**MAP ACCURACY REPORT**  
**Countywide Imagery & DEM**  
**Crow Wing County**

<b>Data Contact Person:</b>	Don Sigety, LS	<b>Department:</b>	County Surveyor
<b>Type of Mapping:</b>	DEM (LiDAR) & Ortho	<b>Contractor:</b>	Merrick & Company
<b>Independent Testing:</b>	Mn/DOT Photo Unit	<b>Contract Delivery date:</b>	2 April 2008

**Project Identification:** Crow Wing County Digital Elevation Model and Orthophoto

# New location needed?

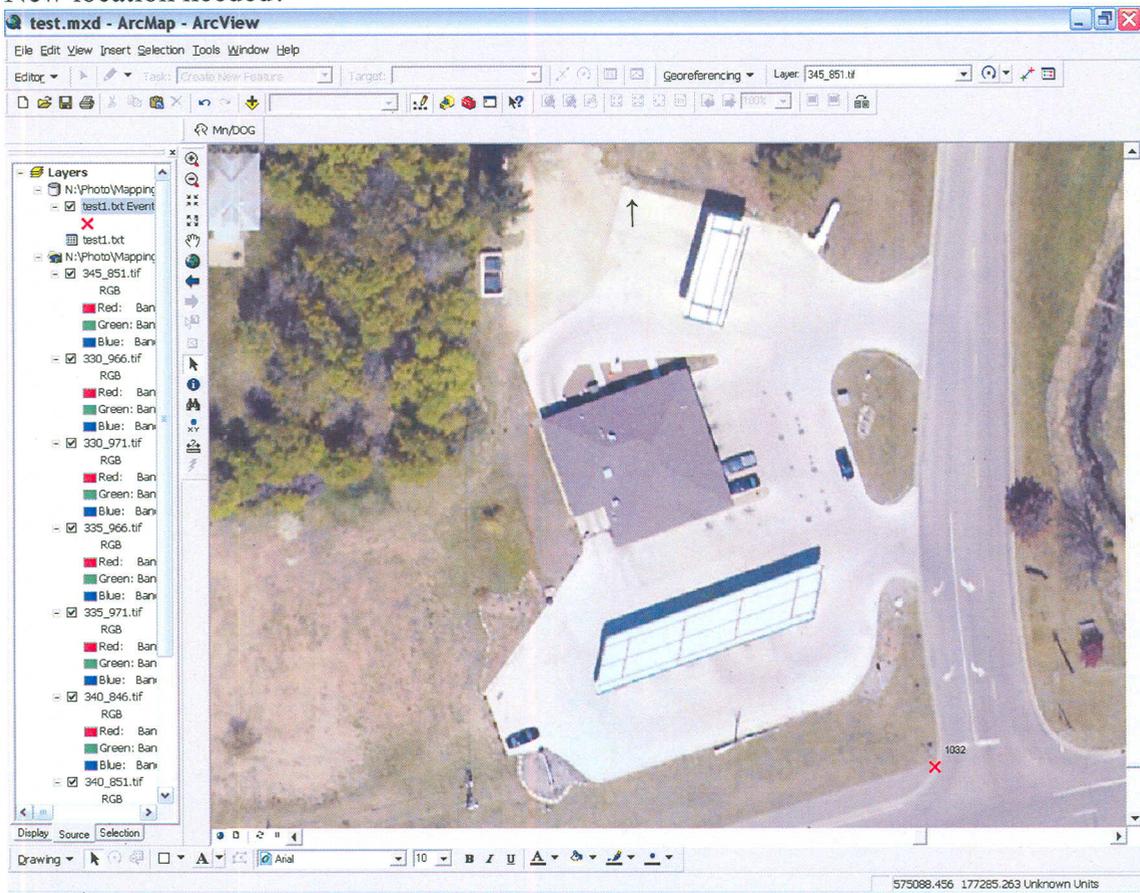
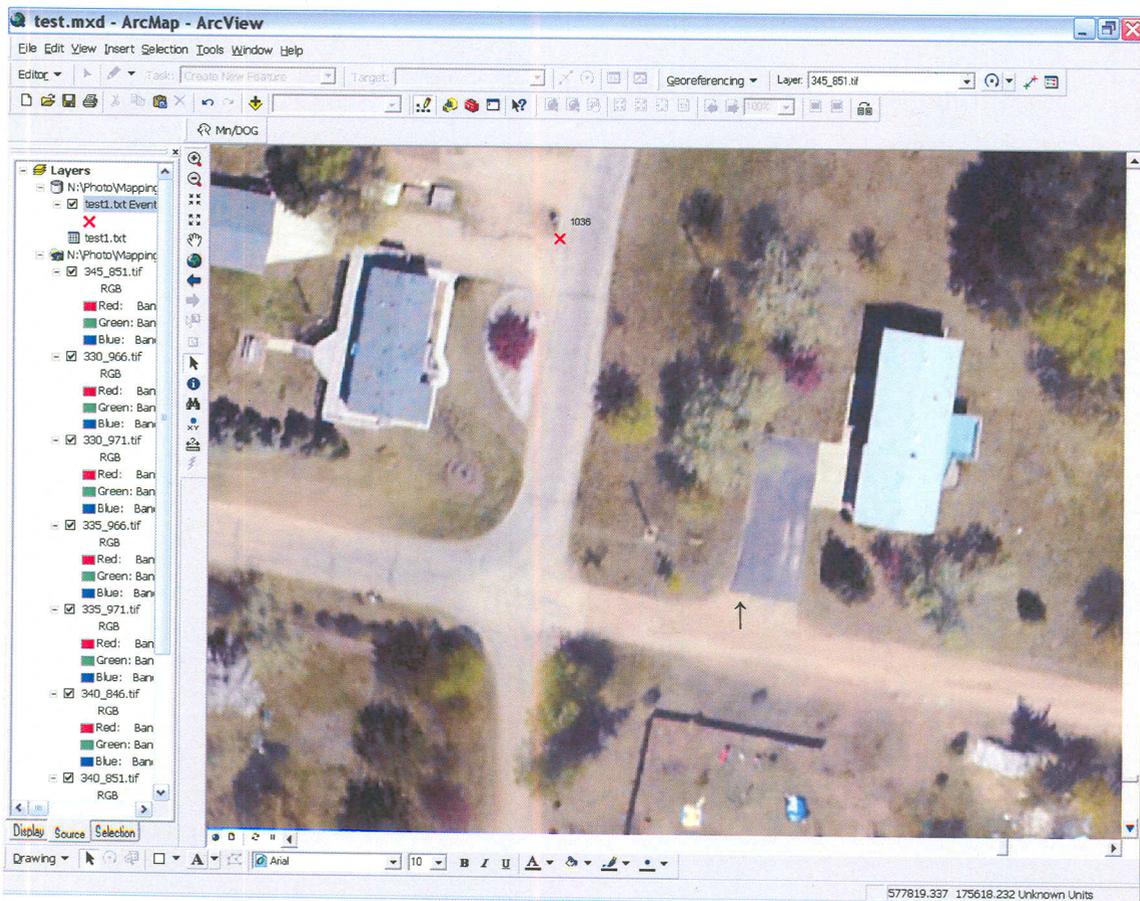
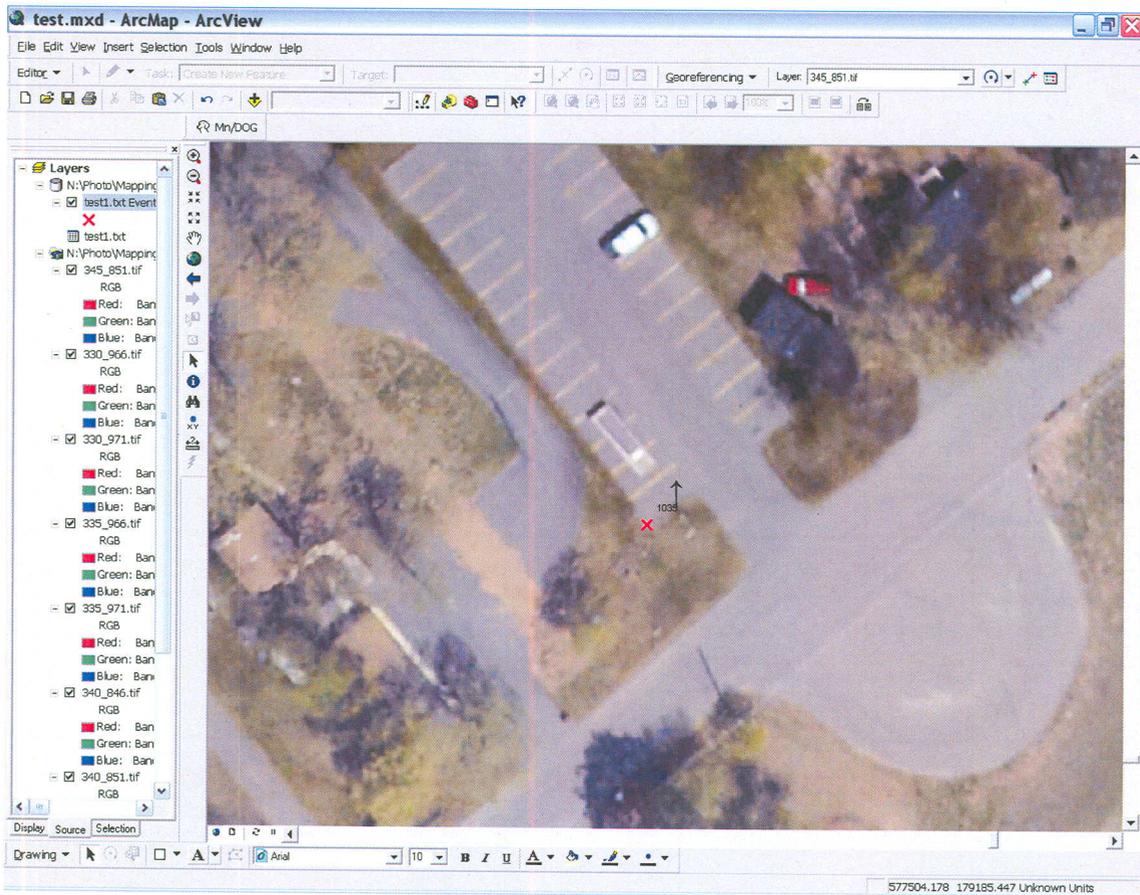
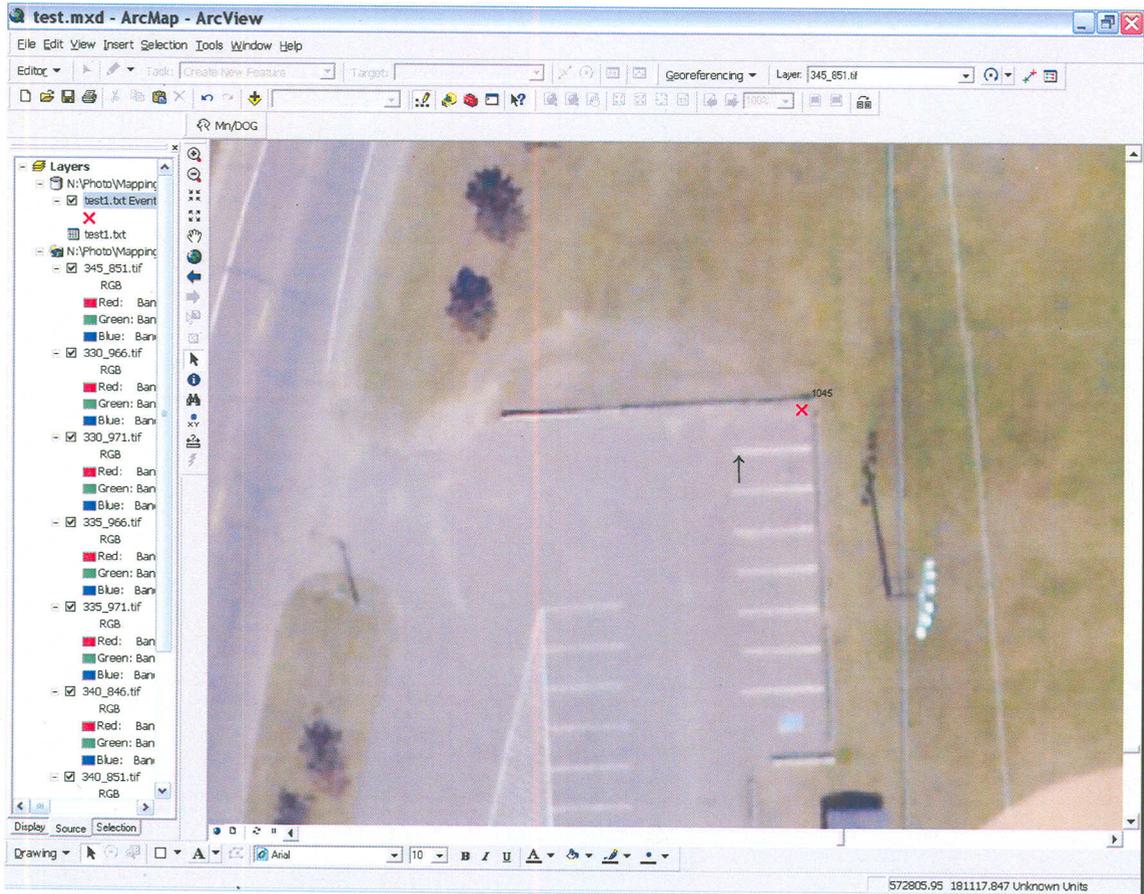
After reviewing the test points and imagery, I have decided that we need to change the location of some of the test shots and some may need to be double stubbed. Attached is a Word document containing screen shots showing the areas where I came up with high residuals or could not make out the exact spot the survey crew shot. The first three images in the word document show points that may need double stubbing. The contrast is good on the image, but the points appear off. The next five images show points where I could not tell what the survey crew shot. The last five images are suggestions of what they could shoot, that show good distinct corners and have good contrast in the photography. I understand that it is near to impossible for the survey crew to know what the camera is going to capture from the sky and that what they see on the ground may look good from 6 ft above but not from 1500 ft. I have also attached the horizontal test sheet so you can compare the screen shots to the test. If you have any questions let me know.
